September 19, 2005  
5928-05-20253U.S. Nuclear Regulatory Commission  
Attn: Document Control Desk  
Washington, DC 20555-0001Three Mile Island, Unit 1 (TMI Unit 1)  
Facility Operating License No. DPR-50  
NRC Docket No. 50-289

Subject: Response To Request For Additional Information –  
Technical Specification Change Request No. 326: Elimination of Containment  
Equipment Hatch Closure During Refueling (TAC No. MC4904)

**RESPONSE TO REQUEST FOR ADDITIONAL INFORMATION  
TECHNICAL SPECIFICATION CHANGE REQUEST No. 326  
ELIMINATION OF CONTAINMENT EQUIPMENT HATCH  
CLOSURE DURING REFUELING**

ENCLOSURE 1, REACTOR BUILDING SHIELD DOOR  
REV. 1, 11/83

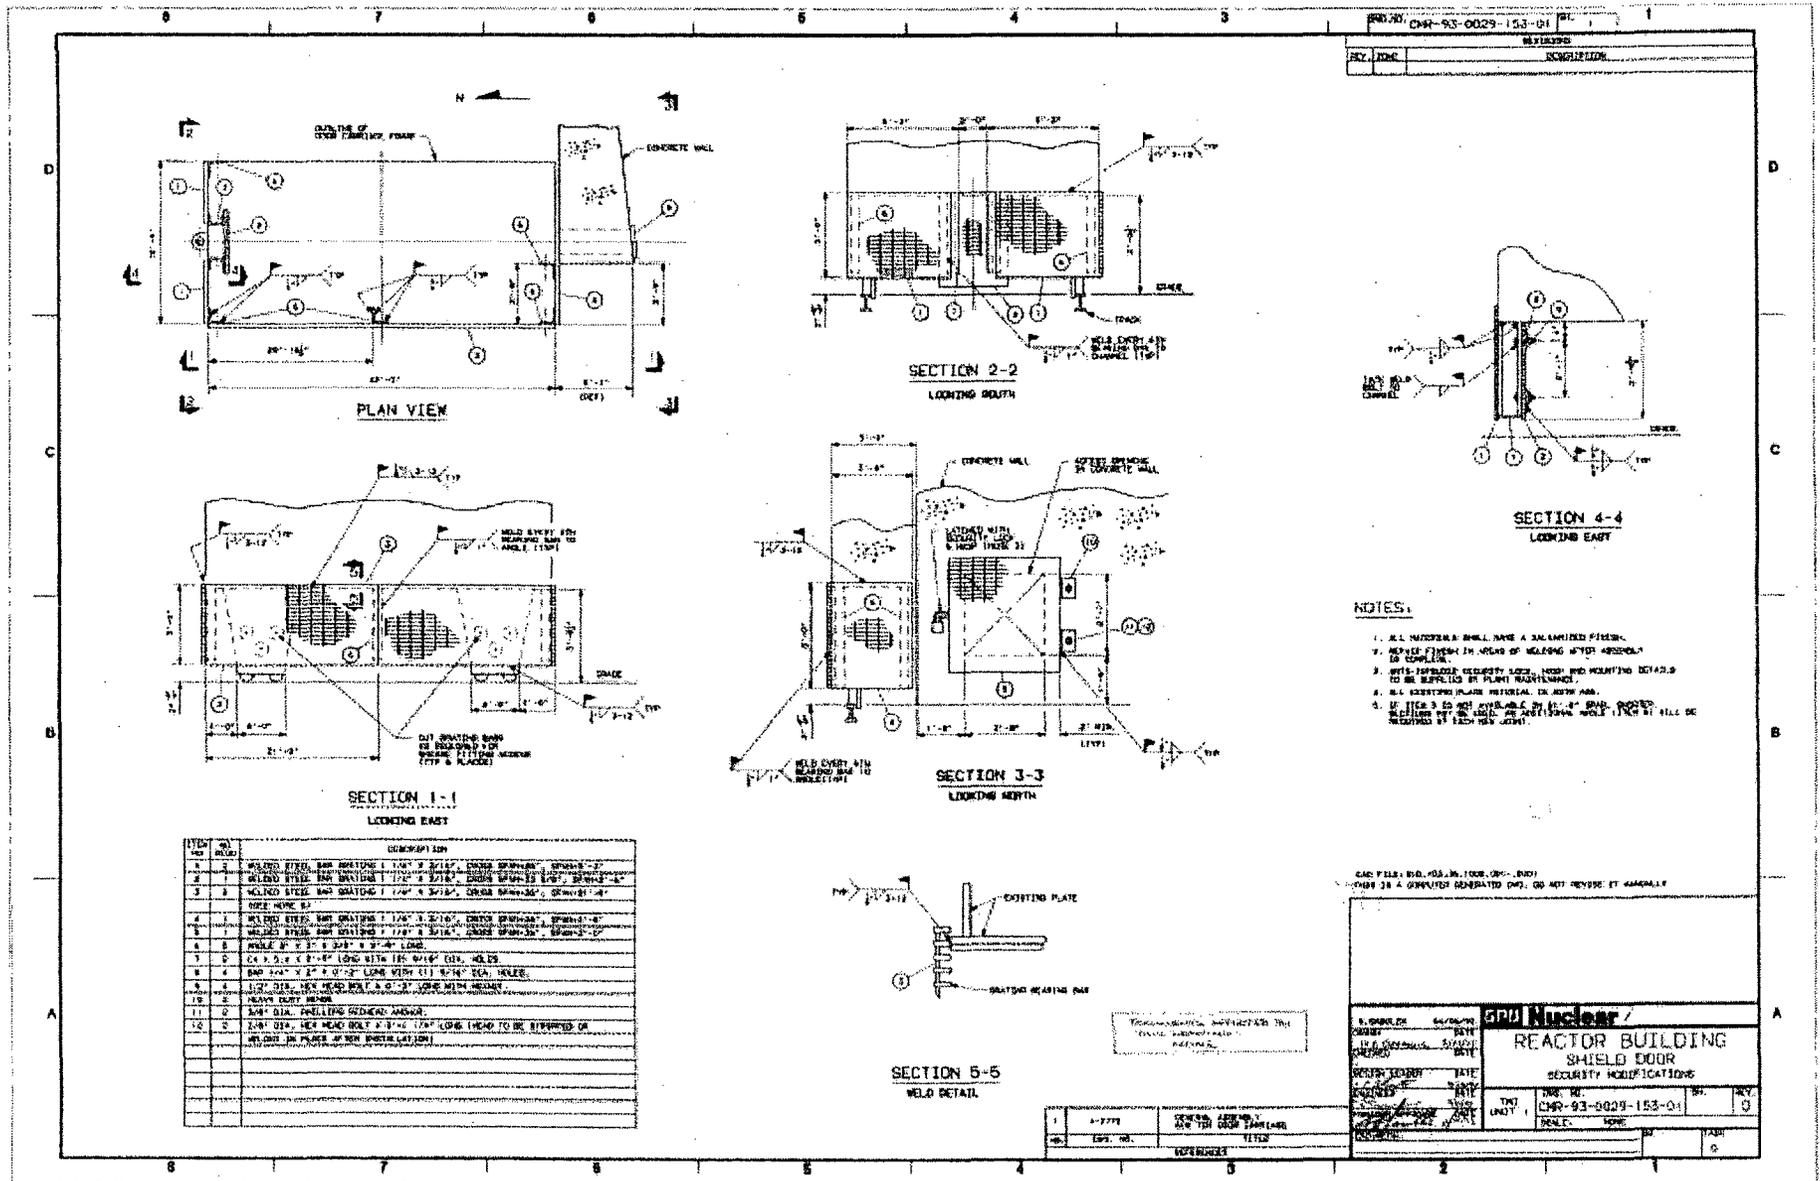
Please provide engineering drawings of the proposed change. A photograph of the equipment hatch would also be helpful in the review of this proposed change. Describe the steps taken to ensure any proposed flashing will not interfere with closure of the Equipment Hatch opening. What is the acceptable design clearance between any proposed flashing on the shield doors and the containment to ensure that the flow after the opening is closed is into containment?

Photographs and drawings of the TMI Unit 1 equipment hatch missile shield barrier are attached. The proposed change permanently adds steel plate to the lower most missile shield carriage area. The added steel plate will cover the area where grating is currently installed. The added steel plate will not create an interference fit, which would interfere with equipment hatch missile shield closure. The equipment hatch missile shield has a 2-inch clearance above the existing asphalt grade. A 3-inch clearance along the vertical face of the missile shield exists at its interface with the extended concrete impact enclosure, which extends from containment. The total area of these clearances with the Reactor Building Purge Exhaust System operating and the missile shield installed, ensure that flow is into the Reactor Building.
